BLYTHE ENERGY PROJECT

Request for Staff Approved Project Modifications (99-AFC-8C)

Southern California Edison's Blythe Eagle Mountain Transmission Line Pole Relocations and Modifications And Double-Circuiting 34 Structures to Accommodate Possible Future Solar Project

June 2009

Figure 1: Existing Locations of B-EM Structure 124605 Relative to Other Lines

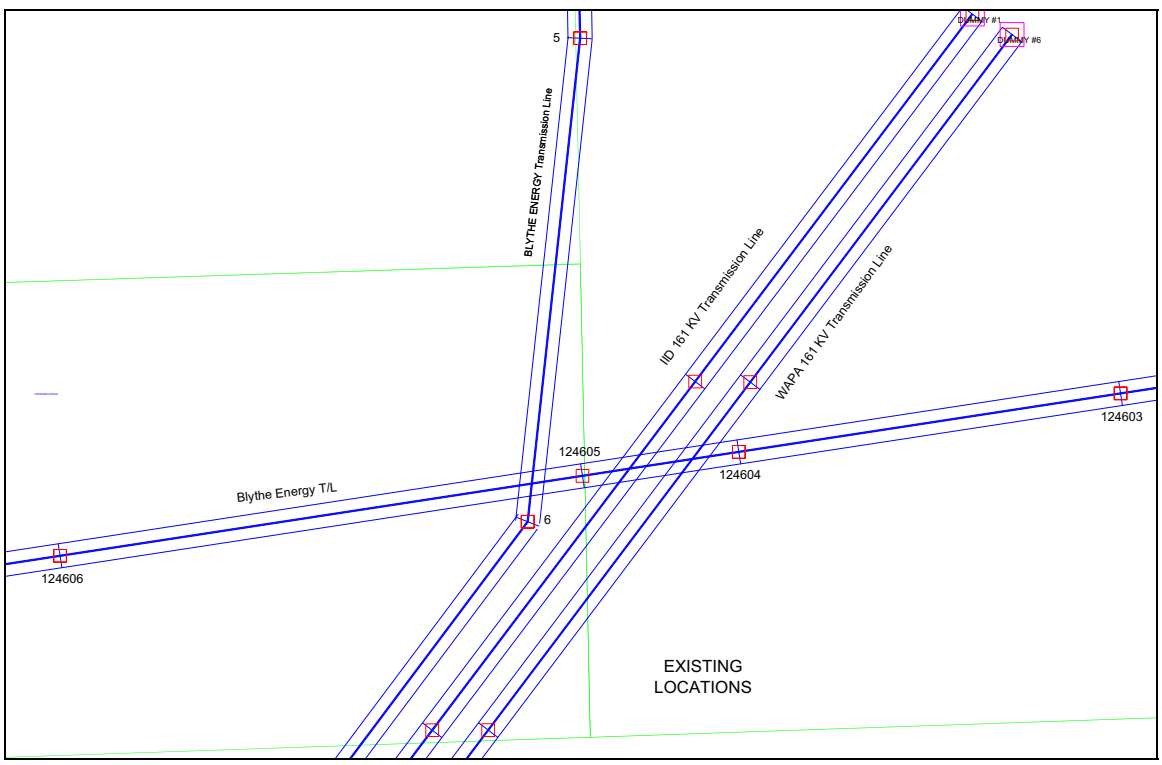
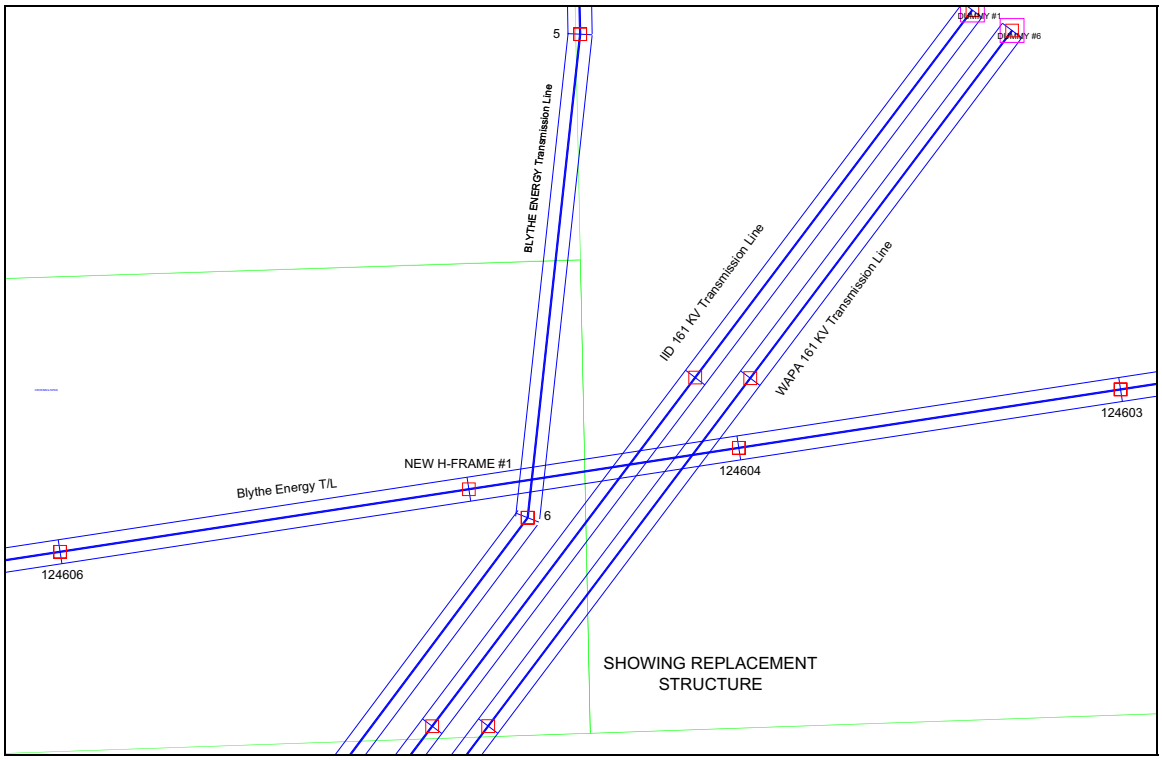
Figure 1 shows the present location of structure 124605 on the Blythe Eagle Mountain (B-EM) line relative to the Blythe Energy Transmission Line (BETL). The BETL turning structure shown below is structure 6 and is adjacent to the power plant property. To accommodate this crossing and allow for future maintenance of the SCE structure requires that it be relocated to the west on the existing alignment by 190 feet. The existing structure is a 90 foot Wood Pole H-Frame structure with the top of pole approximately 79' above the ground (see the attached drawing . The replacement structure will be a geometrically similar 110 foot steel H-Frame with the top of pole 98 feet above ground surface. Its location is shown in Figure 2.

Existing Structure	Replacement Structure
Northing	2169621.206	2169592.468
Easting	7037230.778	7037042.965

1. Installation of New H-Frame with three way guying in place of 124605 but 190 feet to west.
2. Install a replacement steel H-frame of the same configuration but 5' taller at existing location of 124604.
3. Move conductor to new structures. Replacement of suspension hardware at structure 124606 with dead ending hardware. Ahead and back guying of this structure will be required.
4. Remove existing structure 124605.
5. Change suspension hardware on 124603 to dead end hardware and add back and ahead guys.

Figure 3: Existing Structure Location at Freeway Crossing

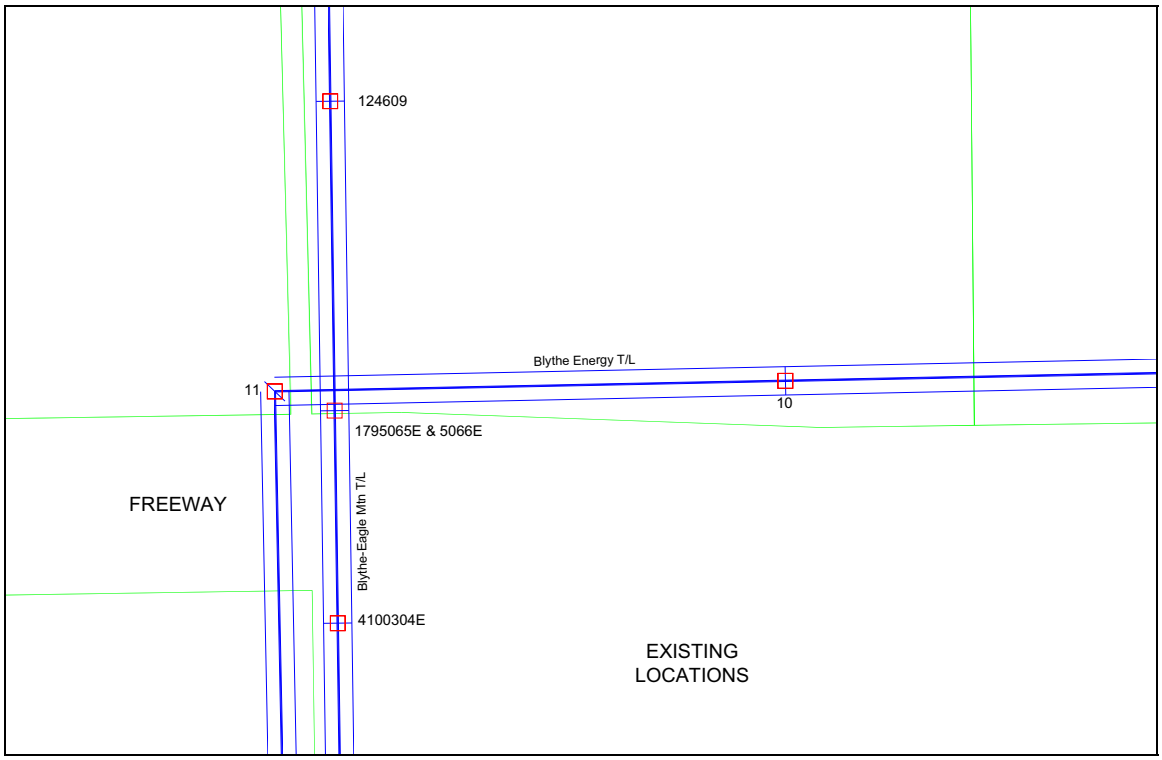
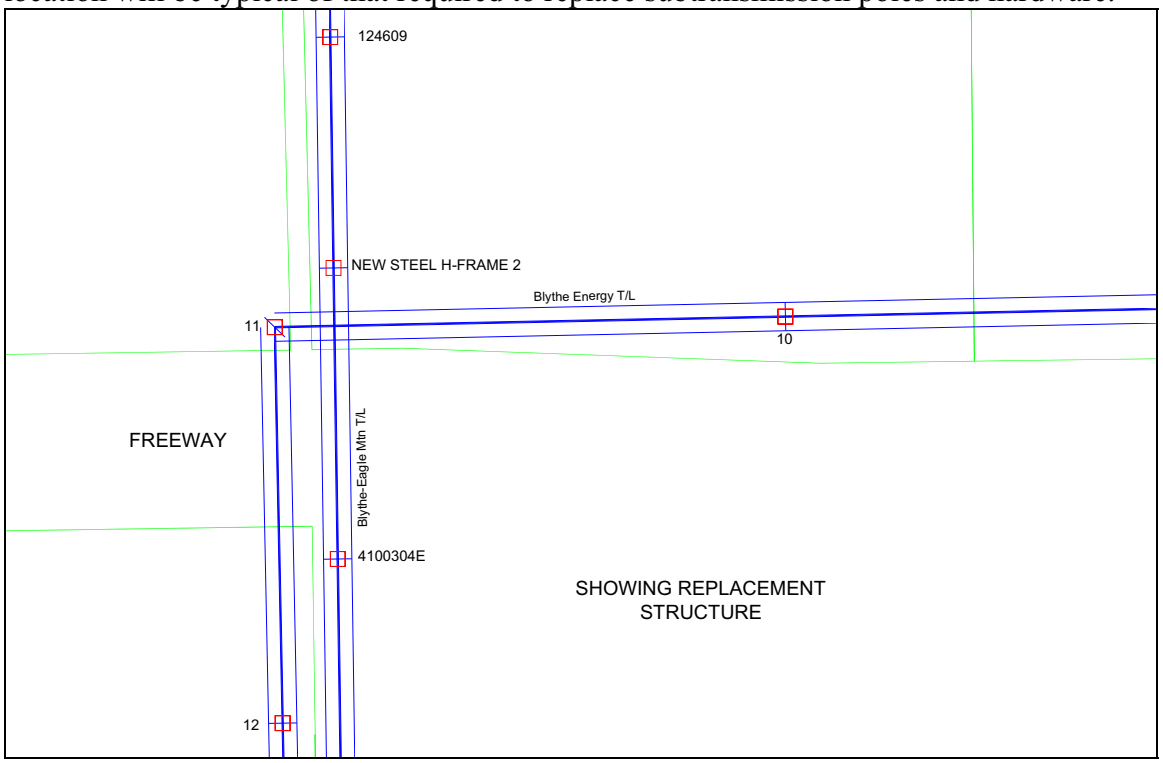
Existing Structure	Replacement Structure
Northing	2168047.564	2168153.483
Easting	7034653.829	7034652.307

The existing SCE structure on the north side of the freeway crossing is a wood pole H-frame with suspension hardware (see attached drawing 438968). The poles are 75 foot long with an above ground height of 66 feet. The replacement structure will be geometrically similar but constructed of steel poles and top of poles will be 71 feet above the ground. The taller structure will necessitate changing hardware on the next structure north to dead end hardware and add back and ahead guys to it (structure 124609 on the Figures).

1. Installation of the New H-Frame 106' north of existing structure 1795065E/1795066E.
2. Installation of 80' H-frame at locatin of structure 4100304E south of the freeway.
3. Attach wires to new structure.
4. Remove existing structures.

5. Replace hardware on 124609 and add guys to north and south.
